BEACON PLANNING BOARD
Via Video-Conference
BEACON, NEW YORK 12508
Phone (845) 838-5002 Fax (845) 838-5026

Conklin Street - Beacon Views

Continue public hearing for SEQRA environmental review on applications for Subdivision and Site Plan Approval, "Beacon Views Townhouses" 39 units, Conklin Street, submitted by Beacon Views, LLC

RE: Beacon Views Site Plan and Conservation Subdivision
Conklin Street
Beacon, New York
Tax Parcel ID: 6055-03-331123

PROJECT NUMBER	19131.100	PROJECT MANAGER	J.J.C.	DRAWING NO.	SP-2.2	SHEET	5
DATE	8-27-19	DRAWN BY	J.F.R.	CHECKED BY	A.D.T.		15
SCALE	1" = 40'

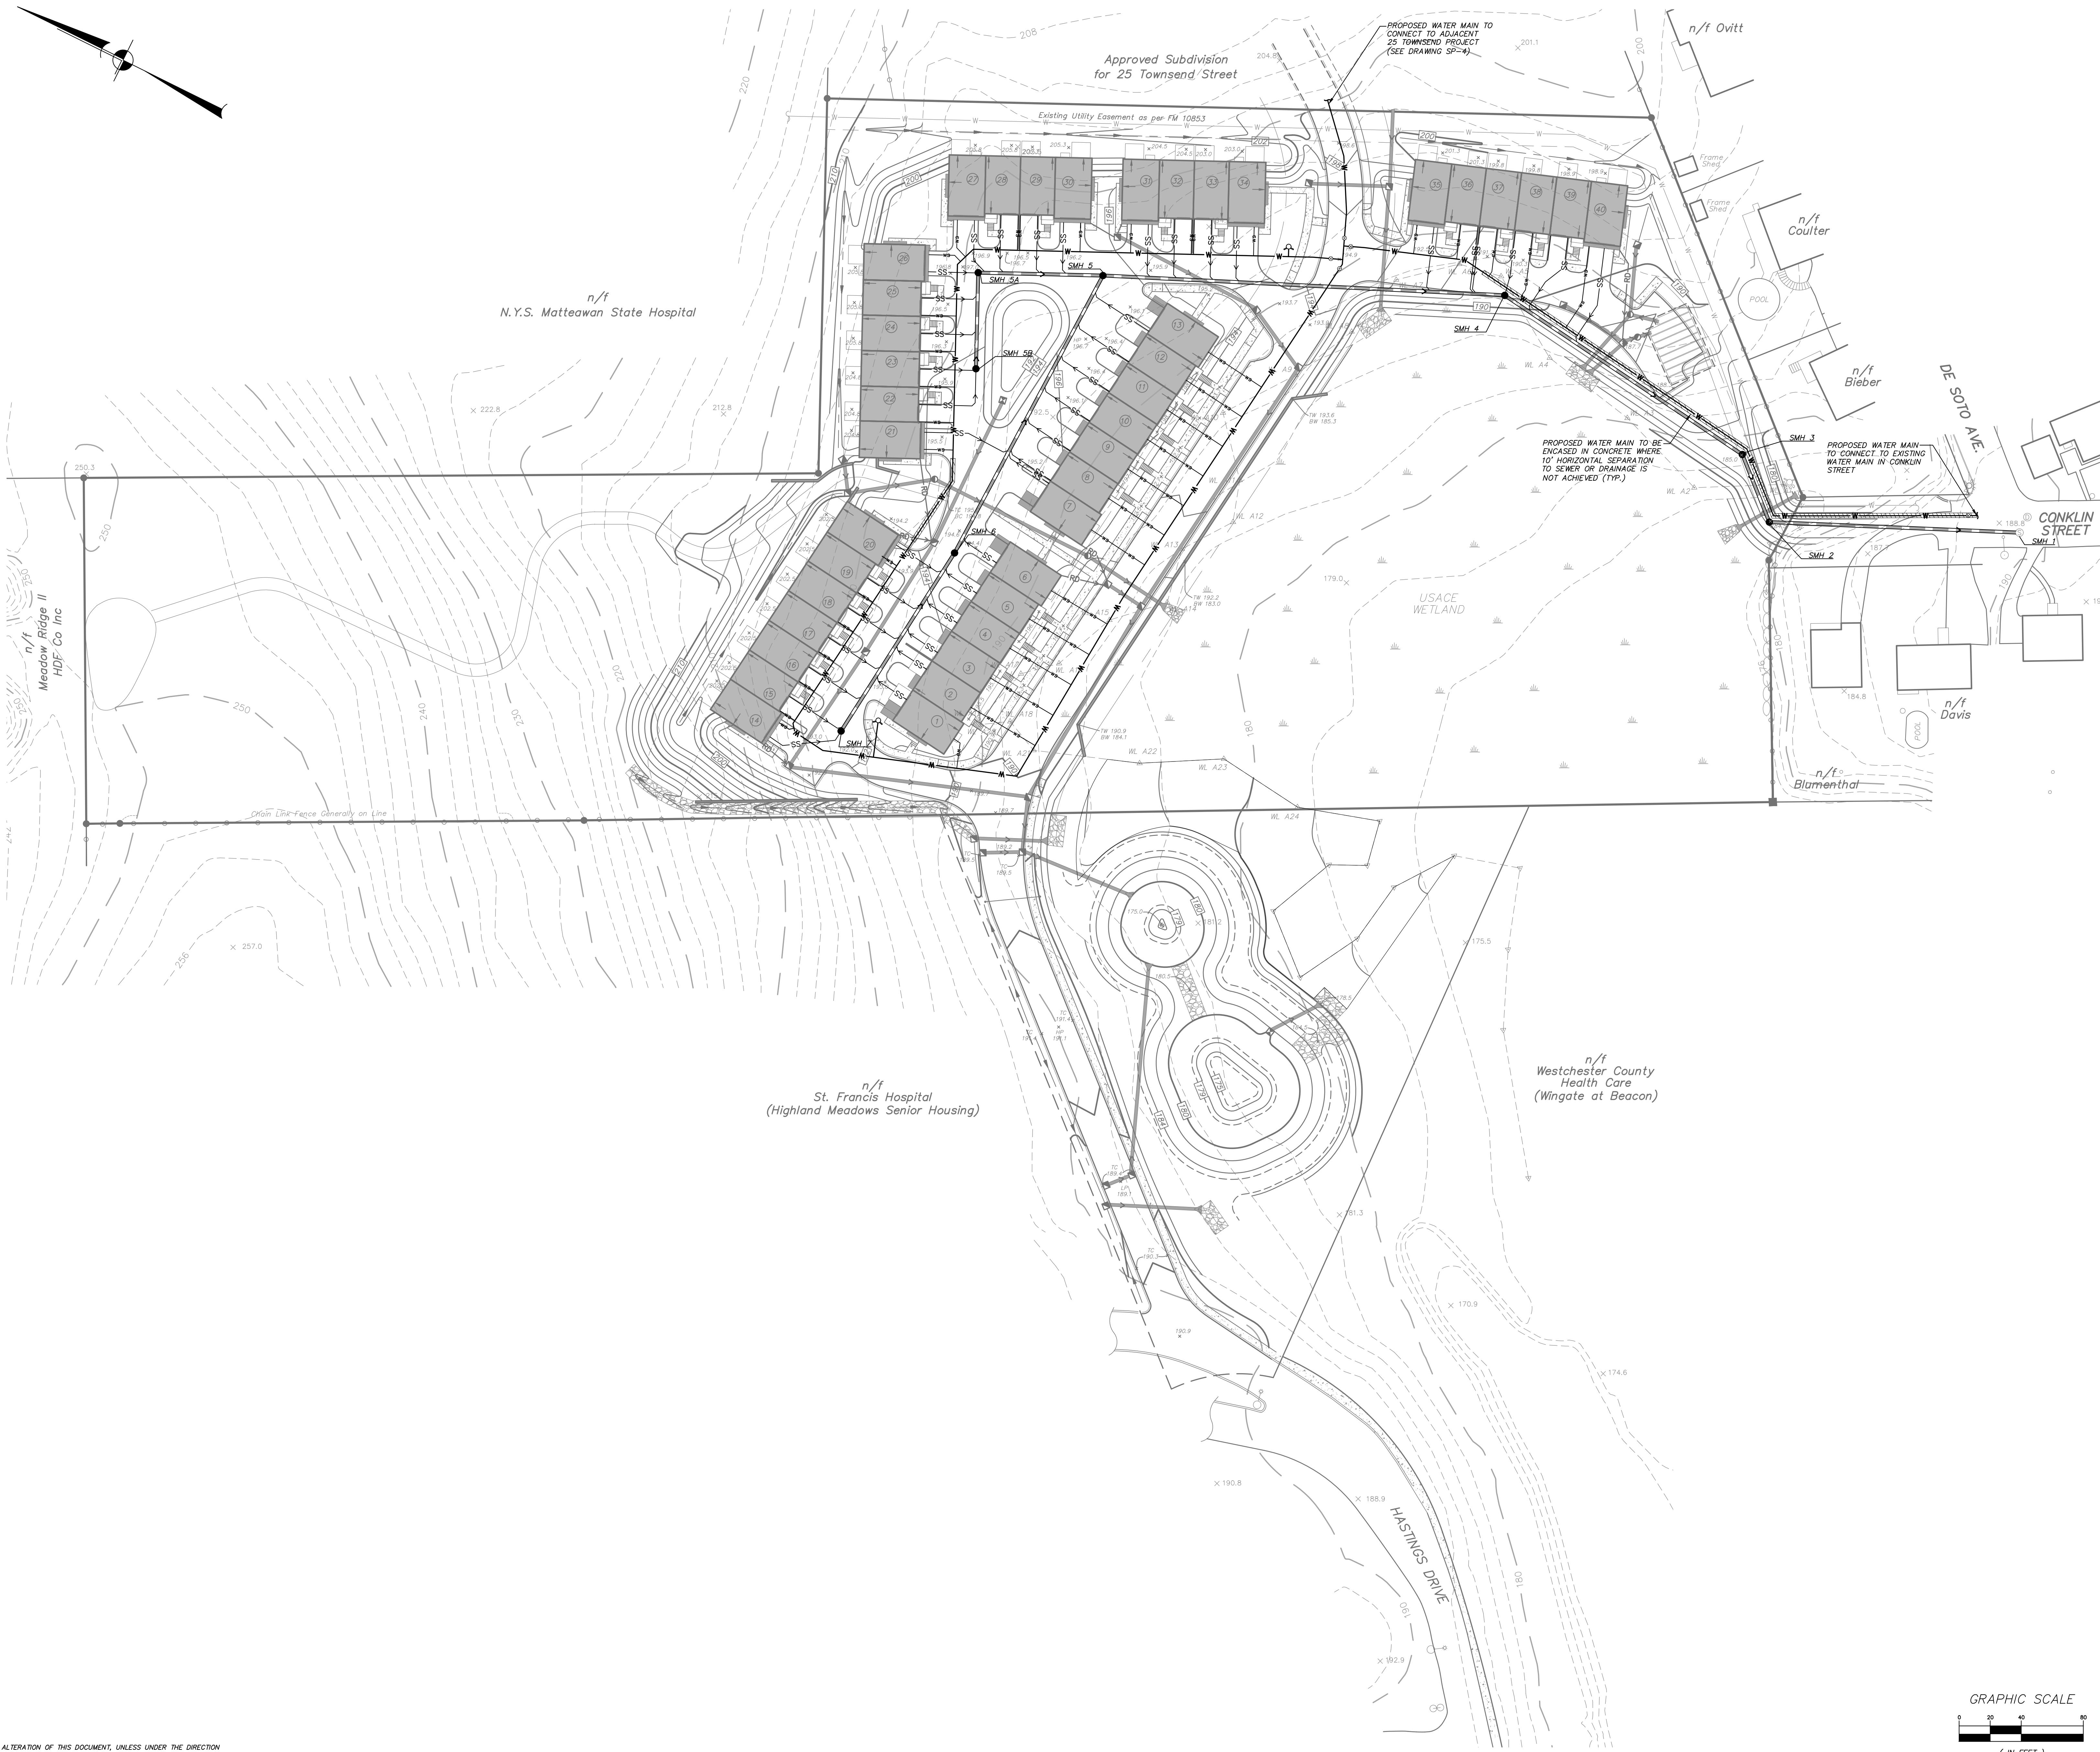
4. The unit numbering is now shown on the Grading & Utilities Plans, which have been broken out into SP-2.1 and SP-2.2.
5. The water line running along the front of units 35 through 40 has been revised to connect to the existing water main at the intersection of Conklin Street and Desoto Ave. A watermain extension is proposed to loop from the intersection through to the proposed water improvements in the proposed subdivision to the north. This will provide additional redundancy in the City water system in this portion of the City.

6. The location of the valves on the proposed water main have been added do Drawing SP-2.2.
7. Each wetland disturbance has been called out with specific square footages.

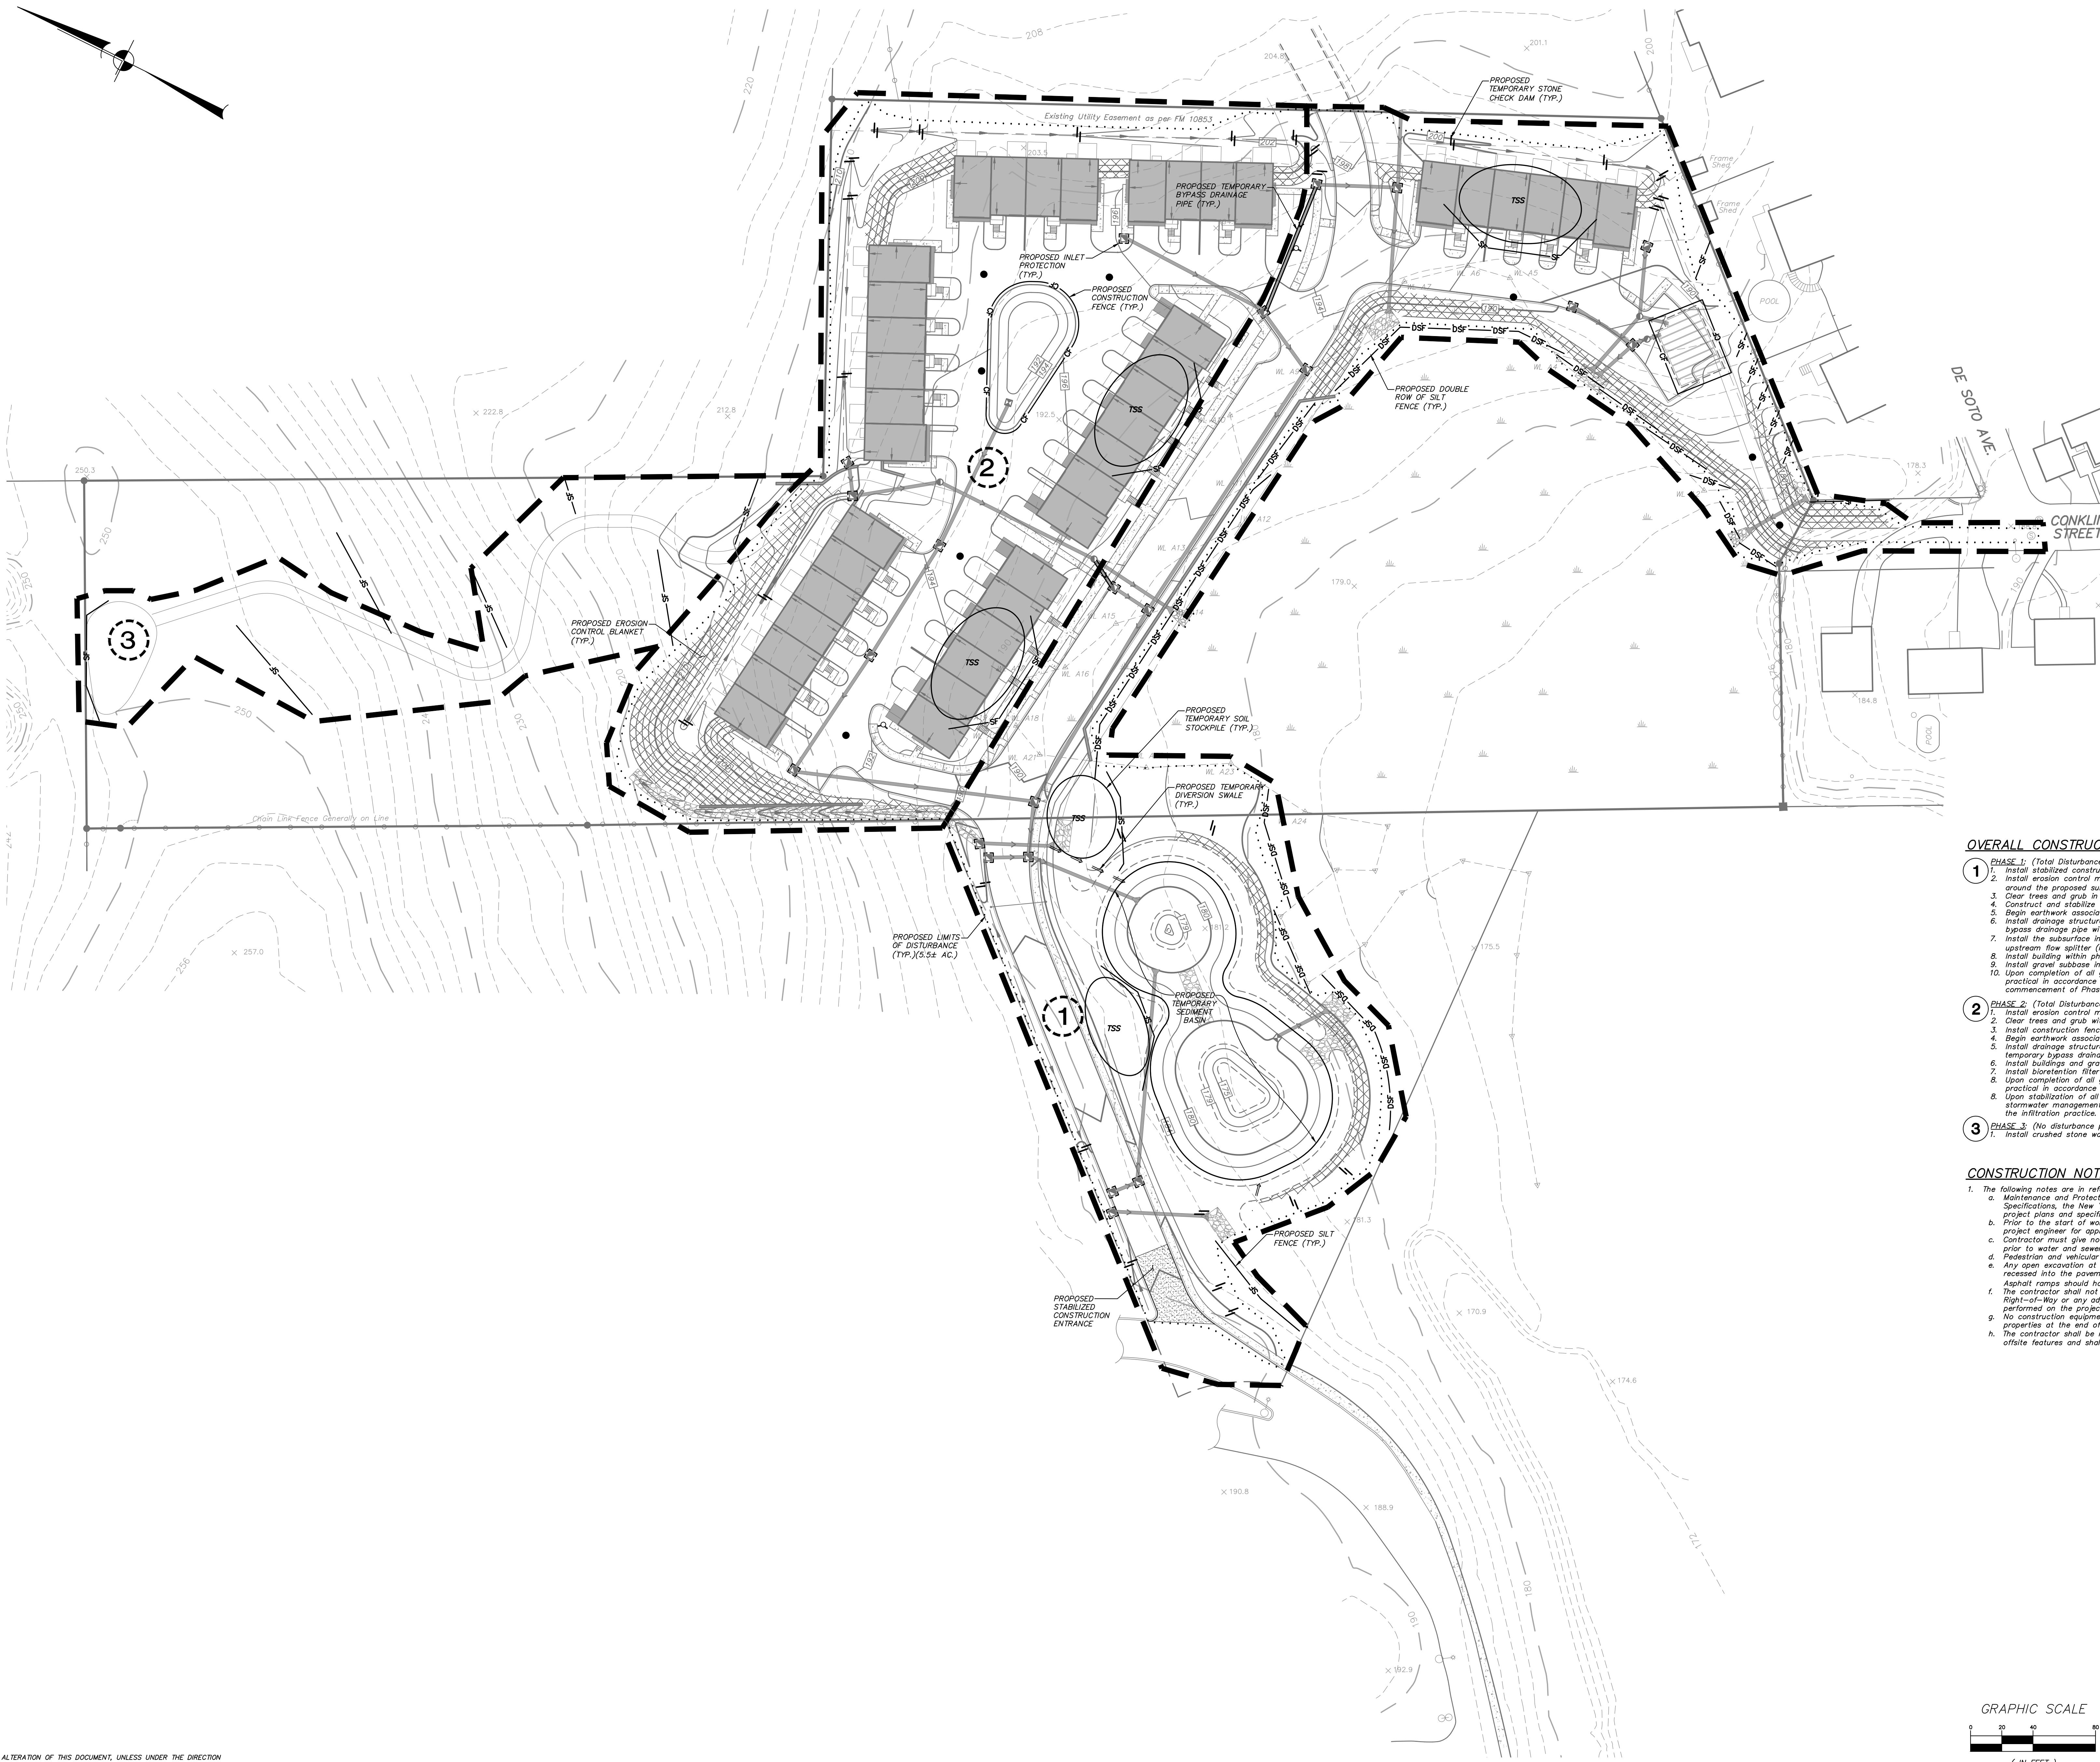
9. Additional details regarding the offsite improvement on Conklin Street have been added to the Construction Notes on Drawing SP-3.
10. It is acknowledged that Emergency Services should review the plans, and a set will be provided to them in the future.

21. Silt fence add been added to Drawing SP-3 within the Phase 3 boundary for the construction of the walking path and passive recreation area installation.
